Reply
to
Submissions
and Preferred
Project
Report

09-0028 Parklands

A report with respect to submissions to
the exhibition of the Environmental
Assessment including a Preferred
Project description and updates to the
project Statement of Commitments.

Prepared for:
North Byron Parklands
Billinudgel Property Pty Ltd

Plan | **1.2**
**Revised Event Area and
Land Use Structure**

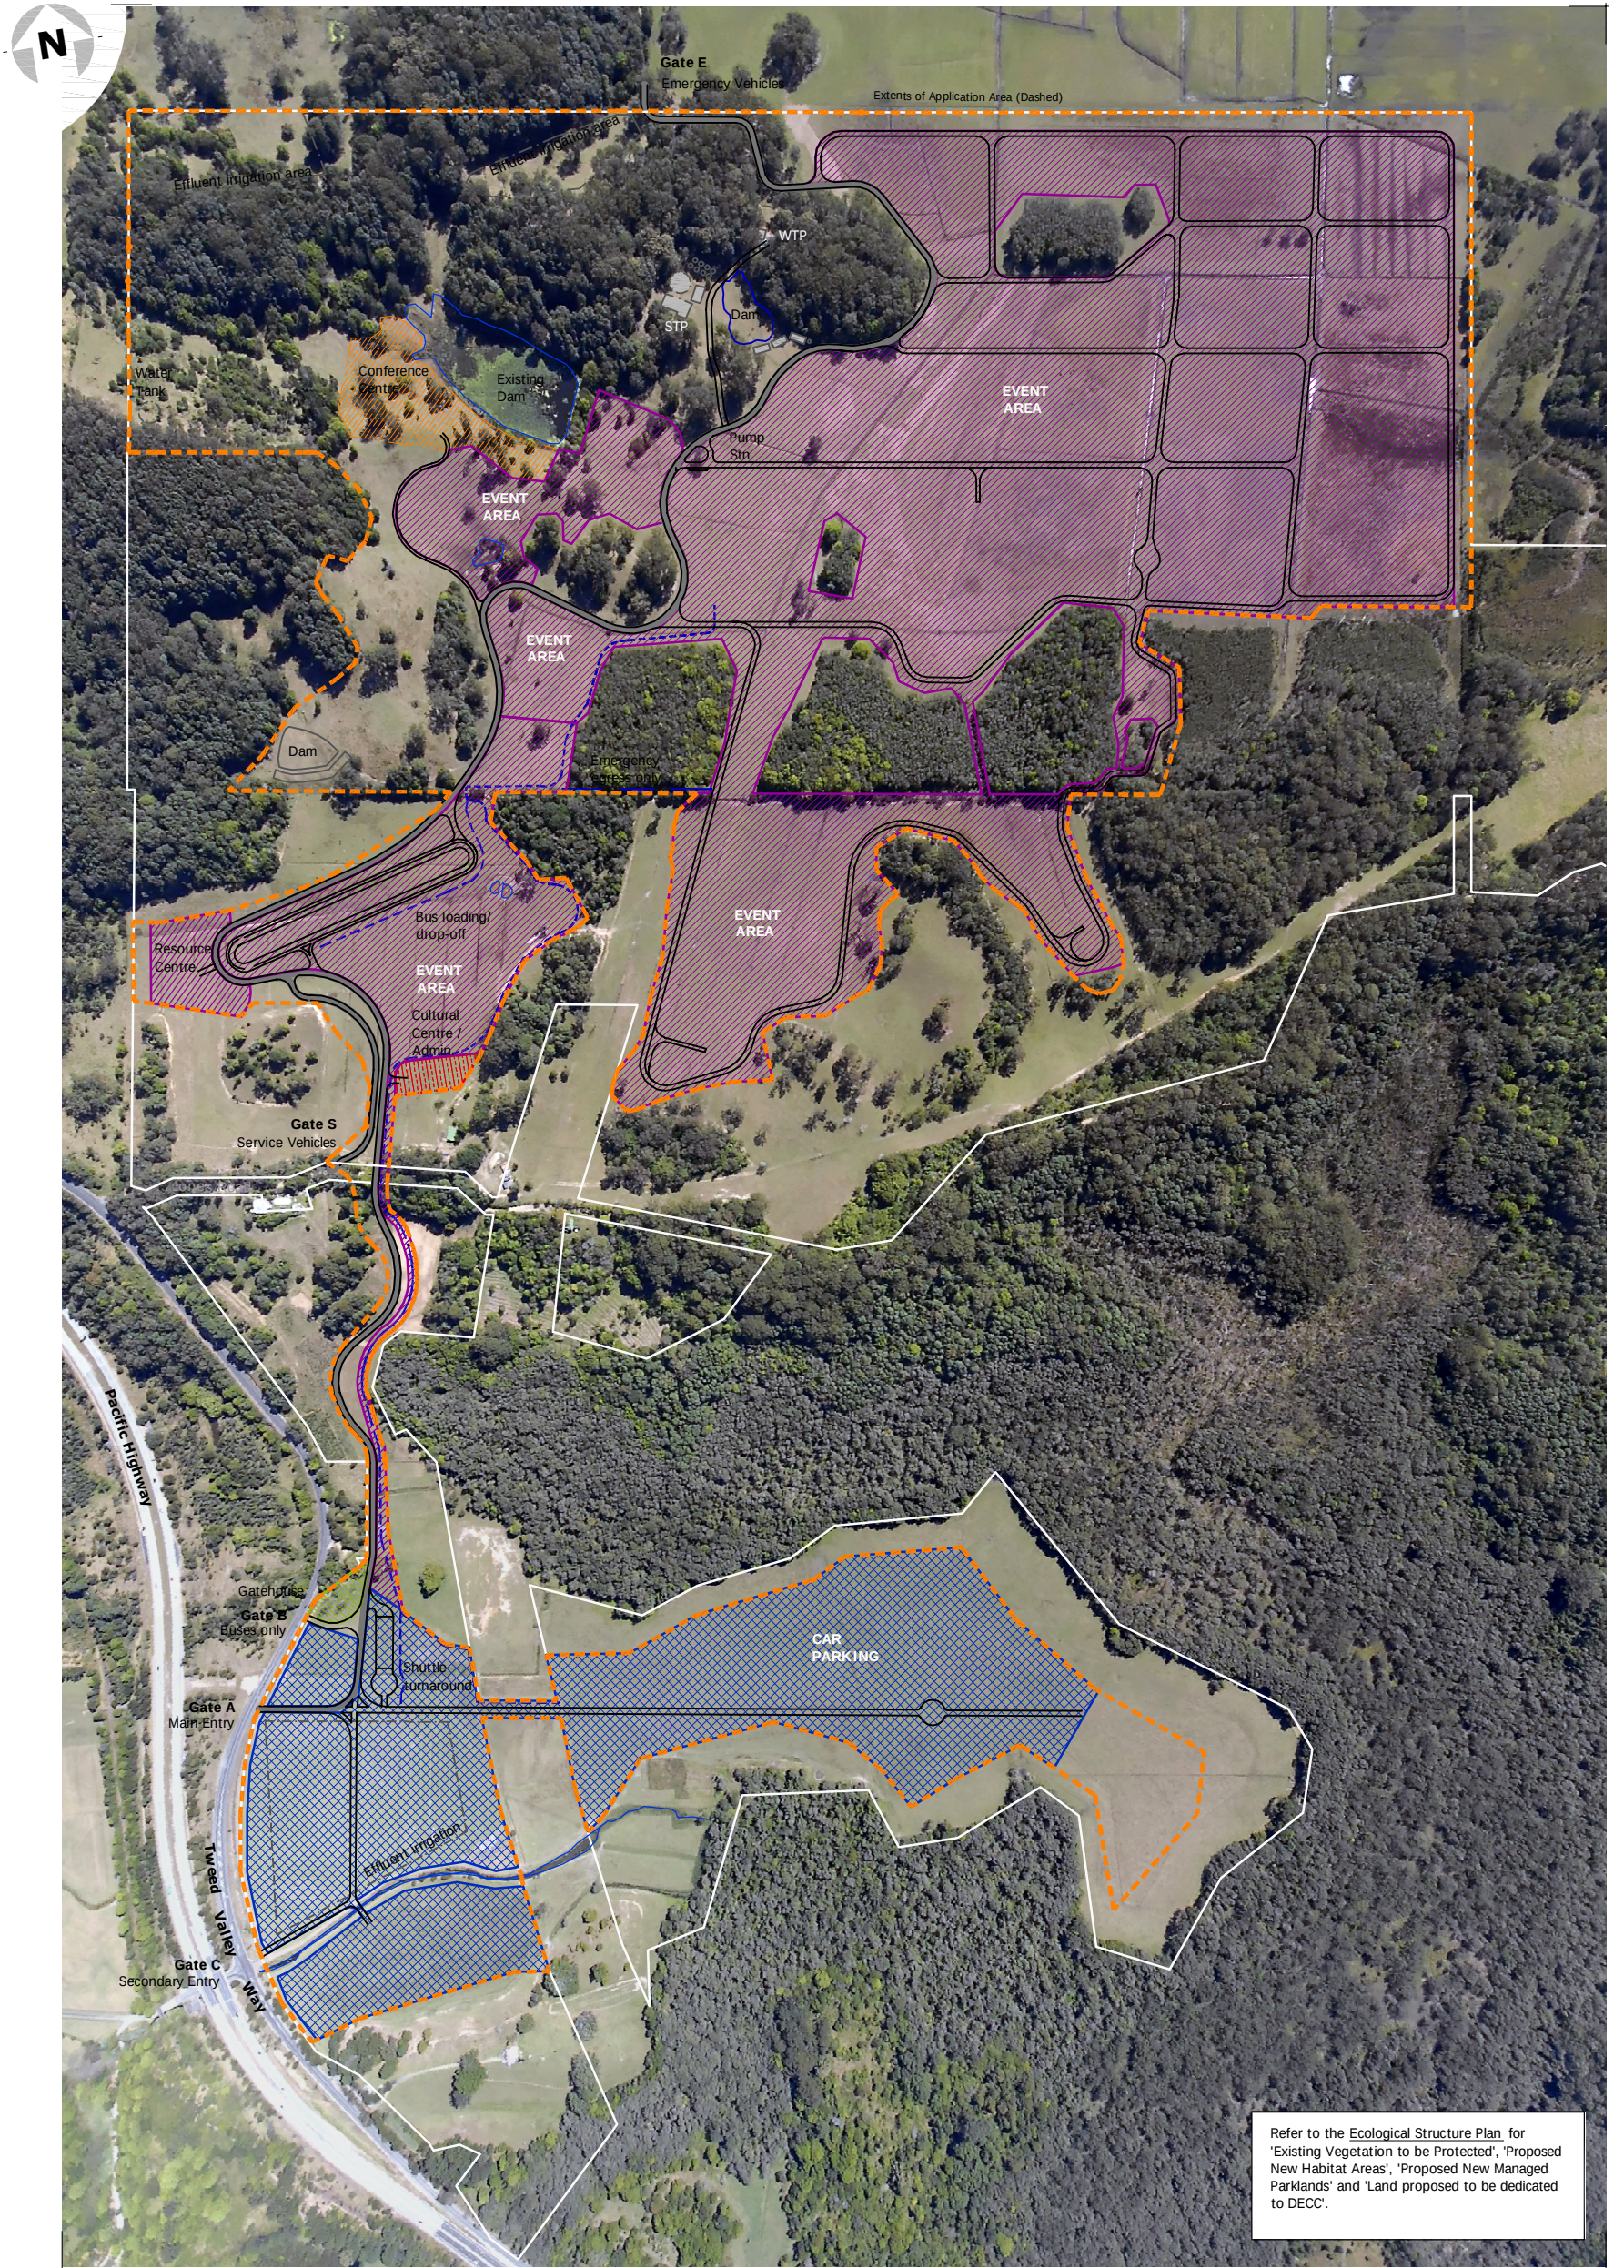
These issues have been discussed in further detail below. Consideration should be given to a reduction in both the size and frequency of events in order to reduce the likely impacts the proposal will have on those residents living in the north of Byron shire, the regions existing infrastructure, and the adjoining environment – including the Billinudgel Nature Reserve.

These measures are shown in updated event and land use structure plan and ecological structure plan (**Plan 1.2** and **1.3**) following.

Plan | **1.3**
**Revised Ecological
Structure Plan**

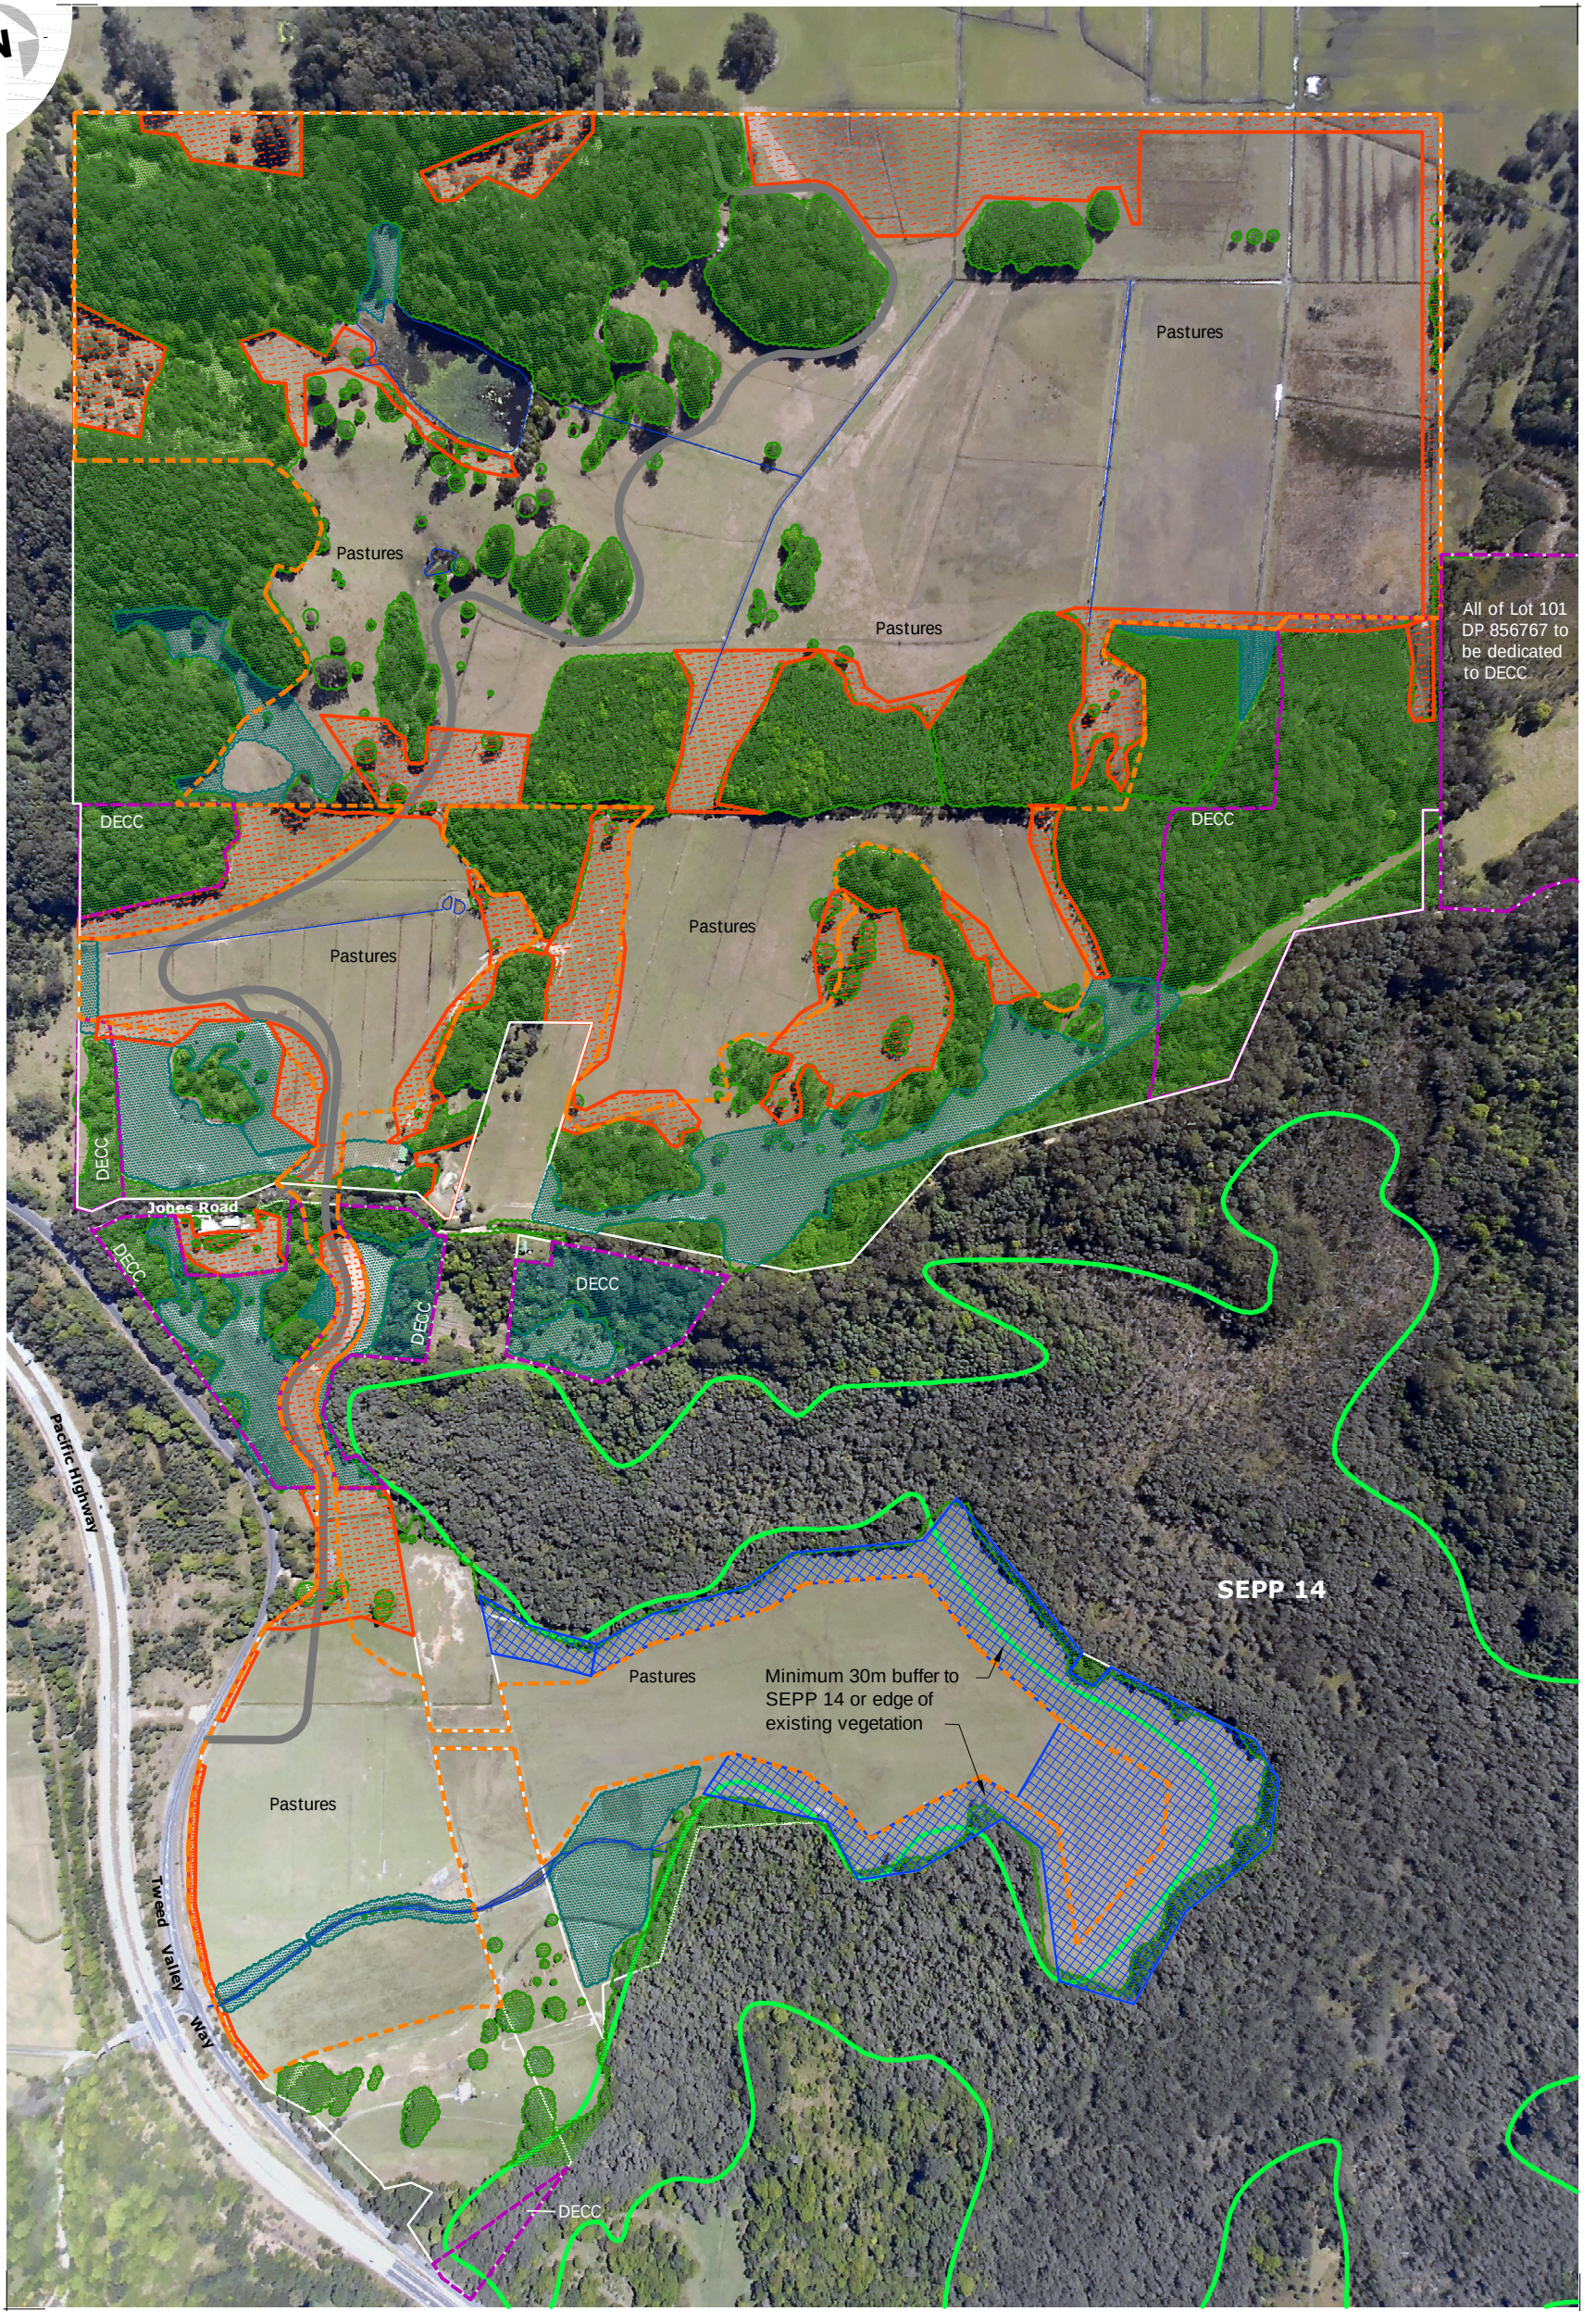
- b. An extensive area of *State Environmental Planning Policy No. 14 – Coastal Wetlands* (SEPP 14 – Coastal Wetlands) adjoins the south-eastern portion of the site. There are significant concerns for the continued functioning and health of the wetland. The effect of up to 50,000 people trampling on soils throughout the site will result in permanent breakdown of the soil structure and facilitate exporting of contaminated surface water during rainfall events into drainage lines which run into the adjoining SEPP 14 – Coastal Wetlands and the Billinudgel Nature Reserve. Further discussion of this issue should be provided.

- c. It is noted that a 30m vegetated buffer is proposed between the southern car parking area and the adjoining SEPP 14 – Coastal Wetland to provide an interception area for run-off. Fencing of this area is also proposed to deter human movement into the wetland. The Ecological Assessment does not provide any information as to why the establishment of a 30m buffer is considered acceptable in order to prevent run-off from entering the wetland. It should be demonstrated, through a qualitative assessment for example, that the proposed 30m buffer will be adequate in capturing all pollutants draining from the southern car parking area. Should this not be achievable, consideration should be given to further mitigation measures, and/or an increased buffer zone between the wetland and the car parking area.

Plan 1.3 Revised Ecological Structure Plan depicts the further increase of the width and size of the buffer to the adjoining wetlands.

NSW I & I (Fisheries) accept the width of proposed buffering to protect the wetlands as described within Section 10 of this report. **Plan 1.3** provides a Revised Ecological Structure Plan which has further increased the width and size of the buffer to the adjoining wetlands. The quantity of edge distance is significantly reduced by this further increase in buffering. The revised Statement of Commitments now proposes that constructed wetlands will be provided within this large buffer area. This buffer area provides a further 12.9 ha. of land dedicated to ecological functioning. Together with the WSUD implementation within the stormwater management plan, these increased buffers will prevent potentially contaminated surface water entering the wetlands.

Rainfall graphs for Byron Bay 2009 and 2010 (Source: Bureau of Meteorology)

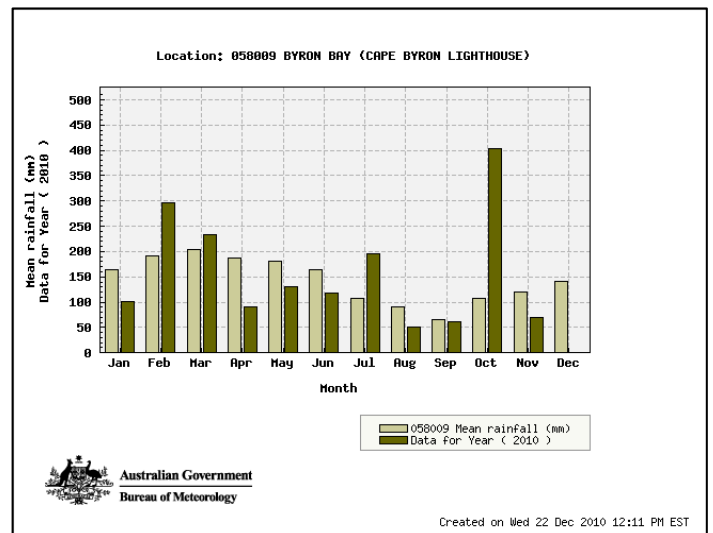
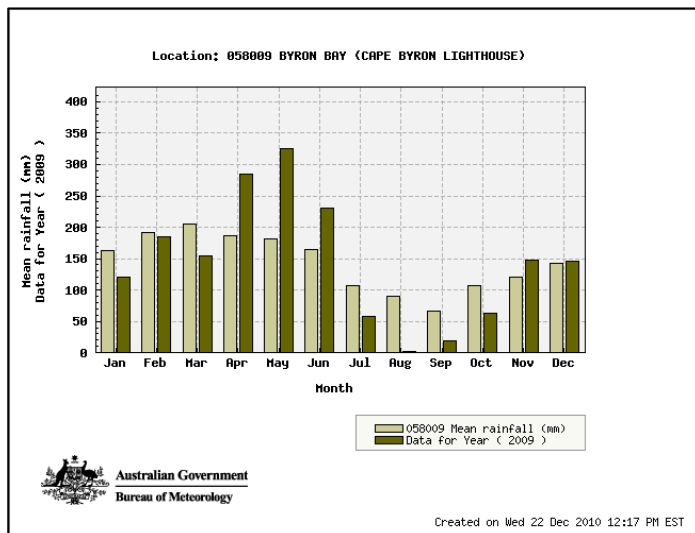
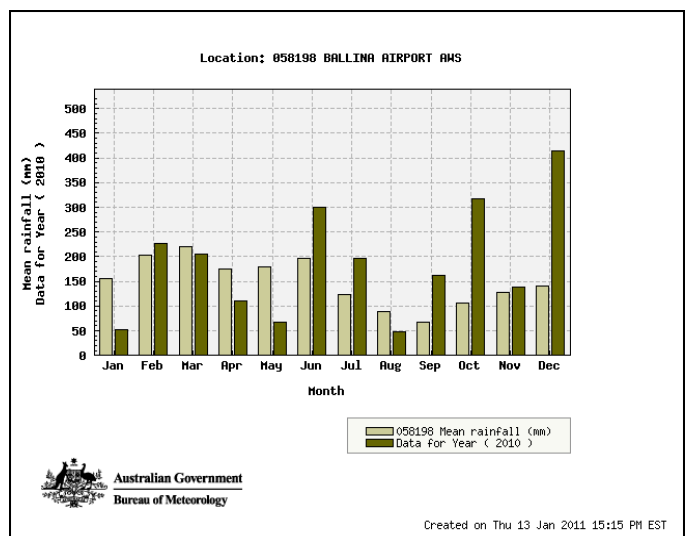
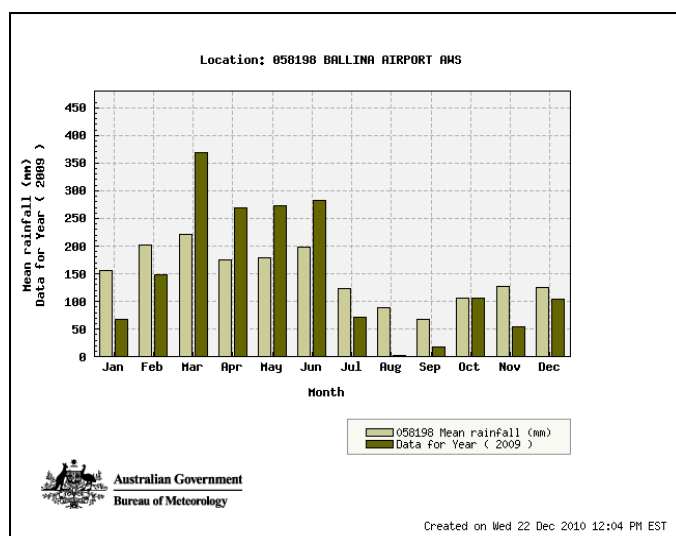
- g. As illustrated in the rainfall graphs below for both Byron Bay and Ballina, the actual monthly rainfall totals in this region regularly exceed the mean average monthly rainfall (including by as much as 400% as is the case for Byron Bay's October 2010 rainfall total). Given the issues raised above in regards to flooding and evacuation of the site, it should be demonstrated whether the project is in fact feasible on a site that is located in a subtropical coastal area known for its highly variable and unpredictable rainfall patterns and is prone to flash flooding.

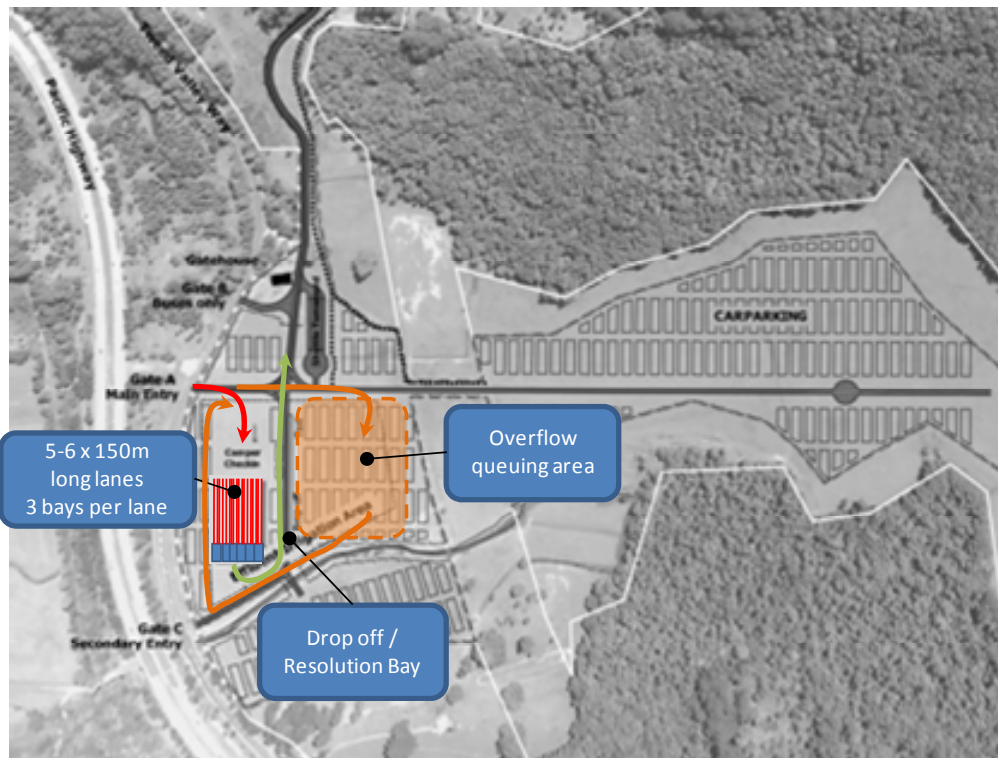
- (e) Concerns regarding the close location/proximity of the "vehicle processing area" to Tweed Valley Way. Delays in processing times could results in the car exiting rate to be slower than the car arrival rate, which could easily and quickly impact on the traffic flows/management/queuing on Tweed Valley Way, and potentially the Interchange/ Motorway. (Similar such scenarios were evident at the recent Blues Festival trial event. The RTA directed quite emphatically, that there is to be NO impact onto the Motorway at all.) The collection and analysis of more accurate traffic data, based on actual events pertinent to this location; could be used by the RTA, Council and the applicant in the modelling, assessment and determination of such events.

The vehicle processing area for campers has been designed with sufficient inspection bays and queuing space to accommodate the required throughput. If camper arrival is larger than anticipated, additional space can be made available on site to get vehicle queues off Tweed Valley Way, as shown in the figure below.
